Access Compliance Report

Public Rights-of-Way

Intersection ID: 14286	Main Street: S_TORRENCE_ST	Cross Street: MAIN_ST	Location:	N
ADA ID: 20ACE342ACFF	Ramp Type: PerpDiag	Initial Pass/Fail: Fail	Overall Compliance: No	Severity Score: 10

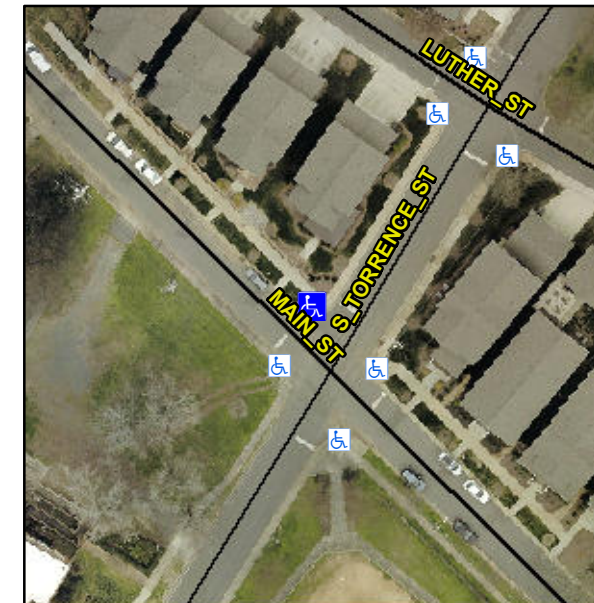
Not Found, R304.5.1, R304.5.3

Compliance	Description	Data	Compliance	Description	Data
N/A	Ramp Length (in)	65.0	Yes	Ramp Slope (%)	7.4
No	Ramp Width (in)	36.0	No	Ramp XSlope (%)	4.5
N/A	Flare Type LT	N/A	N/A	Flare Type RT	N/A
N/A	Flare Slope LT (%)	N/A	N/A	Flare Slope RT (%)	N/A
N/A	Flare Traversable LT?	N/A	N/A	Flare Traversable RT?	N/A
N/A	Landing Length (in)	N/A	N/A	DWS Provided?	N/A
N/A	Landing Width (in)	N/A	N/A	DWS Contrast?	N/A
N/A	Landing Slope (%)	N/A	N/A	DWS Length (in)	N/A
N/A	Landing X Slope (%)	N/A	N/A	DWS Full Width?	N/A
N/A	Landing Curb? (Y/N)	N/A	N/A	DWS Offset (in)	N/A
N/A	Shared Landing?	N/A			
N/A	Gutter Ponding?	N/A	N/A	Gutter Slope (%)	N/A
N/A	Gutter Lip Ht (in)	N/A	N/A	Gutter X Slope (%)	N/A
N/A	Painted X Walk1?	No	N/A	Painted X Walk2?	No
	X Walk 1 Direction	To SW		X Walk 2 Direction	To SE
N/A	X Walk 1 Width (in)	N/A	N/A	X Walk 2 Width (in)	N/A
	X Walk 1 Slope (%)	1.3		X Walk 2 Slope (%)	3.1
	X Walk 1 X Slope (%)	1.0		X Walk 2 X Slope (%)	0.8

Remove & Replace Curb Ramp With Two New Directional Ramps or Equivalent.
